Errata No. 97-2

TO: All holders of the **July 1997 edition of the Standard Plans Book**

SUBJECT: Errata

The attached Revised Standard Plans (RSPs) and New Standard Plans (NSPs) dated August 6, 1998 contain revisions and additions to the July 1997 edition of the Standard Plans Book and are being issued as Errata No. 97-2.

REVISED STANDARD PLAN RSP A77A

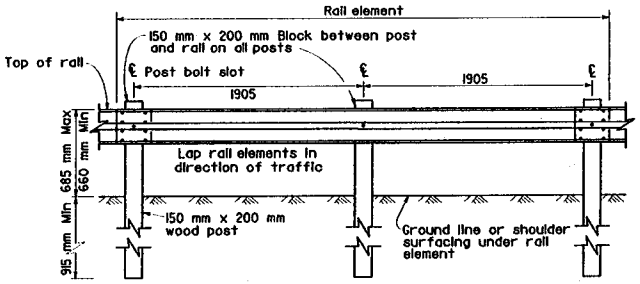
RSP A77A - Revises the sheet to eliminate the steel post with steel block guard railing installations. The use of a flat plate washer under the button head bolt attaching the rail element to the line post has been eliminated. Flat plate washers are to be used only where shown on the plans. A plan for steel post with notched wood block guard railing will potentially be available at a later date provided such a configuration passes additional NCHRP 350 crash test requirements.

REVISED STANDARD PLAN RSP A77C

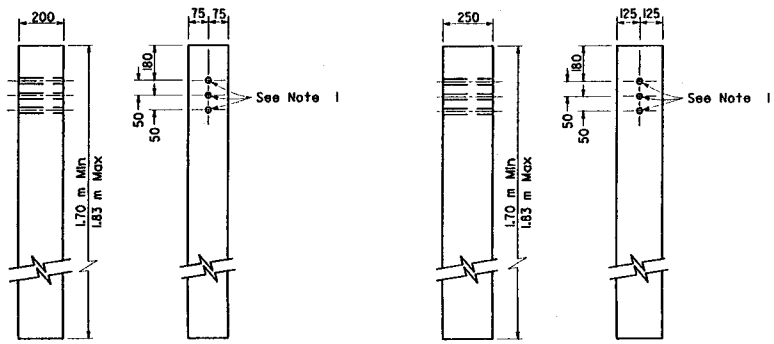
RSP A77C - Revises the sheet to reflect deletion of steel post with steel block guard railing installations.

REVISED STANDARD PLAN RSP A77D

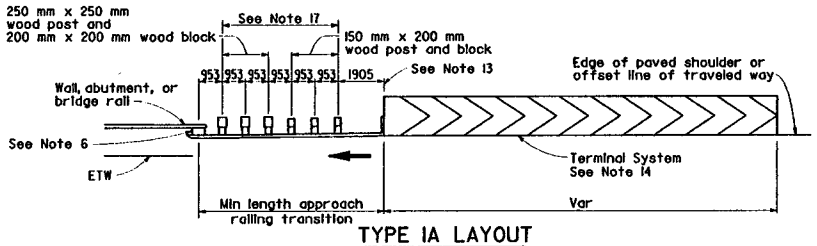
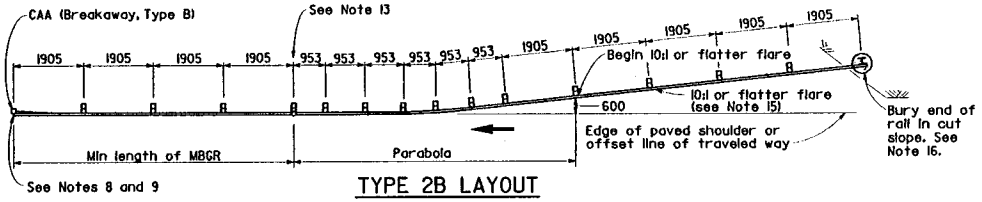
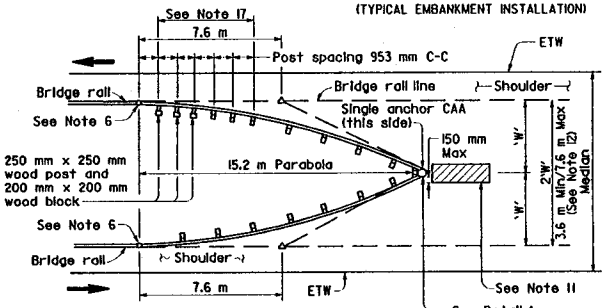
RSP A77D -Revises the description of guard railing installations to numbered layouts instead of flare types to reflect use of flared or in-line terminal systems depending on site conditions. Former Type 1M Flare has been renamed and split into two details -

Type 1A Layouts for structure approach installations and Type 1B Layouts for embankment installations. Former Type 9 Flare (from Standard Plan A77E) has been moved to this sheet, split into two details and renamed - Type 2A Layouts for structure approach installations and Type 2B Layouts for embankment installations. The 7.6 m parabolic flare and associated 10:1 or flatter flare approach details for Type 2 Layouts have been further defined. The parabolic offset formula and detail has been added.

REVISED STANDARD PLAN RSP A77E

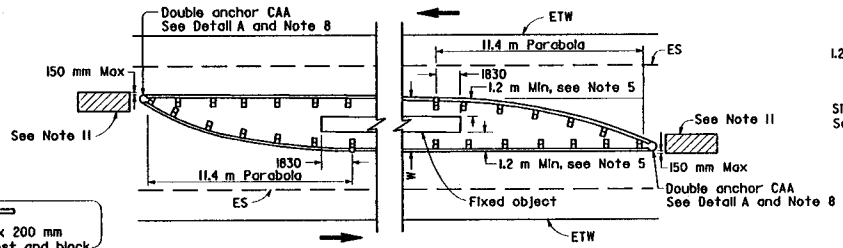
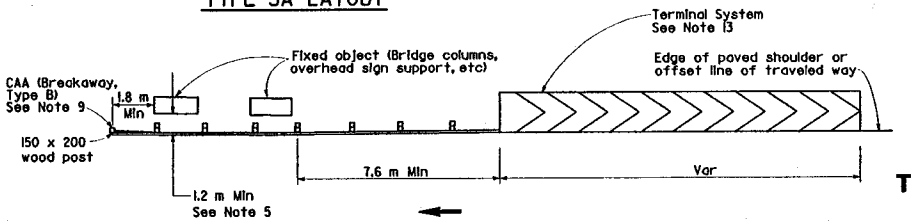
RSP A77E - Revises the description of guard railing installations to numbered layouts instead of flare types to reflect use of flared or in-line terminal systems depending on site conditions. Former Type 4 Flare (from Standard Plan A77D) has been moved to this sheet and renamed Type 4A Layout. Former Type 8M Flare has been revised to reflect use if terminal system end treatment and renamed Type 8A Layout. The parabolic offset formula and detail has been added.

REVISED STANDARD PLAN RSP A77F

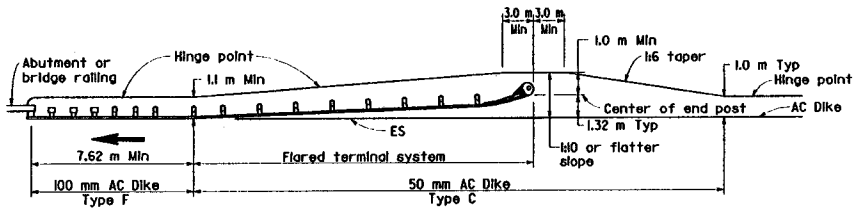
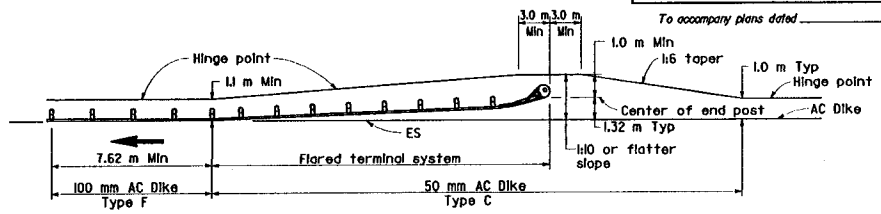
RSP A77F -Revises the embankment widening details to show flared end treatments and in-line end treatments. Post footing details have been moved to New Standard Plan NSP A77FA.

NEW STANDARD PLAN NSP A77FA

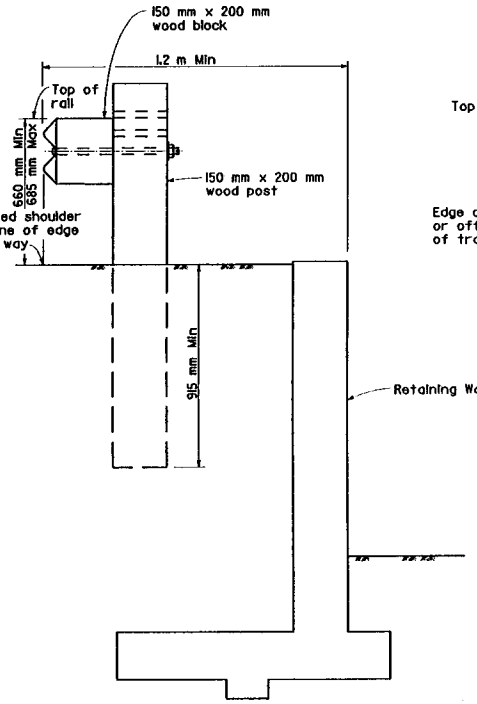
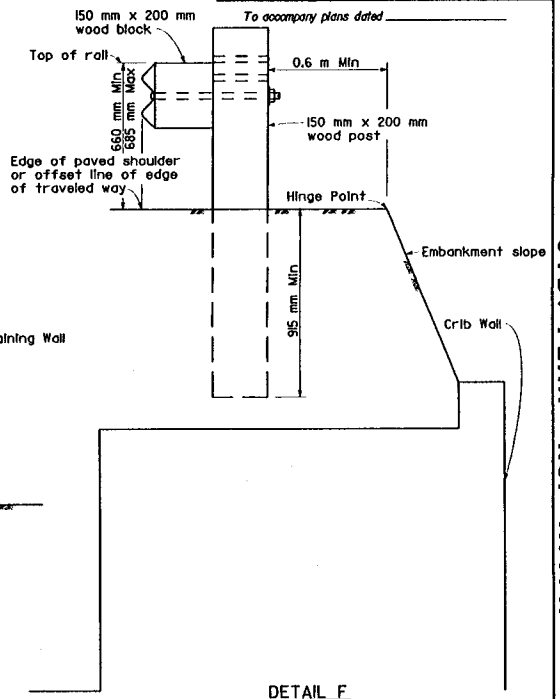
NSP A77FA - Provides new details for typical post embedment for embankment installations. Post footing details (from Standard Plan A77F) have been moved to this sheet.

REVISED STANDARD PLAN RSP A77G

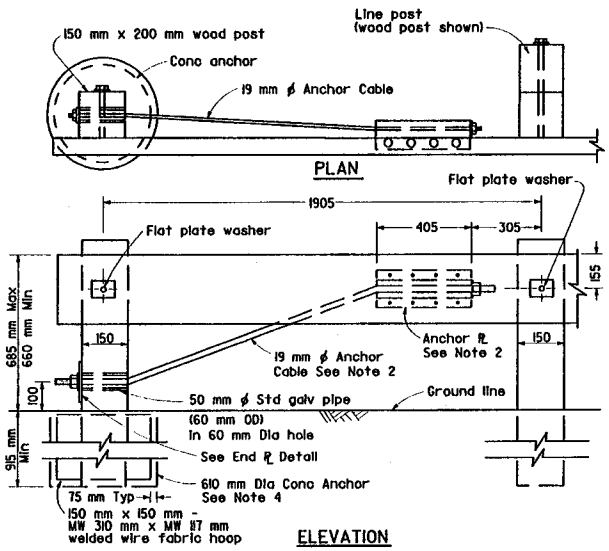
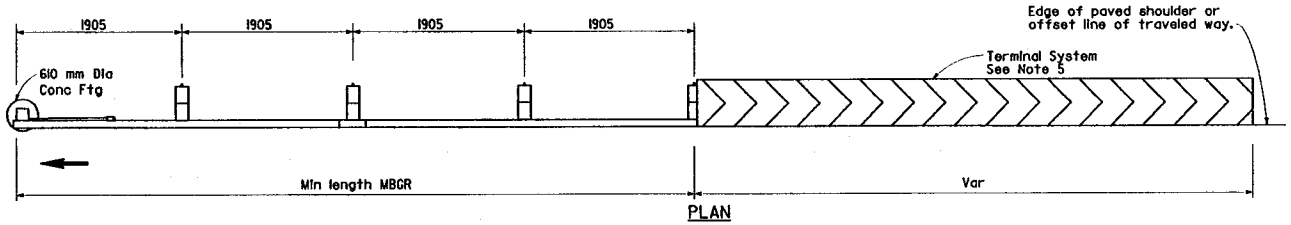
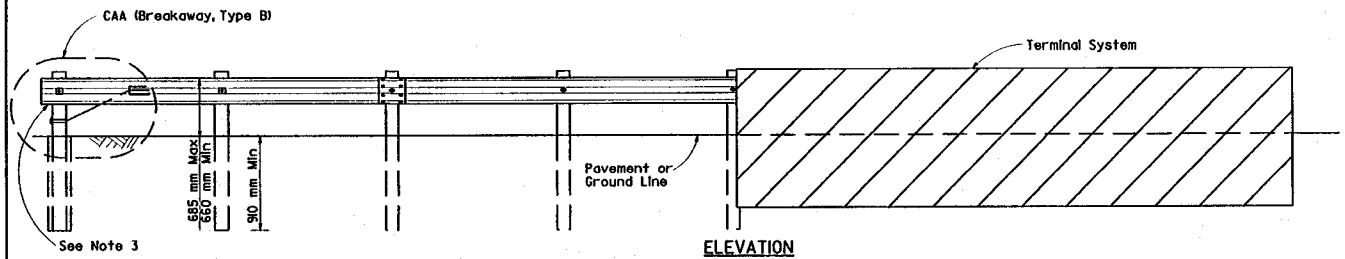
RSP A77G -Deletes details for Type M end treatment and replaces Type M with terminal system end treatment.

DOUBLE THRIE BEAM BARRIER

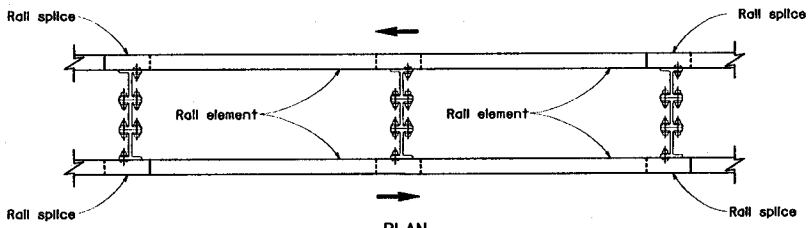
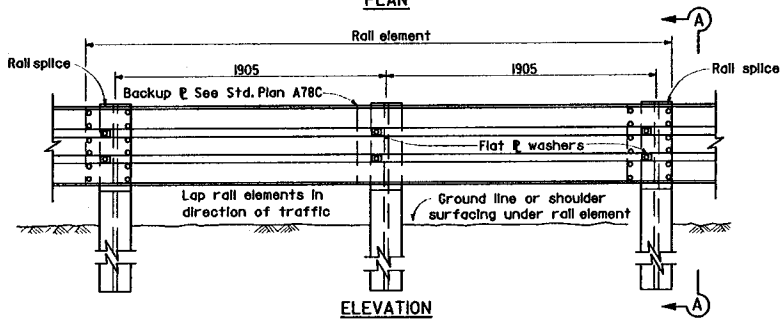
RSP A78B - Revises plan view of Double Thrie Beam Barrier to correctly show steel post and steel block connections.
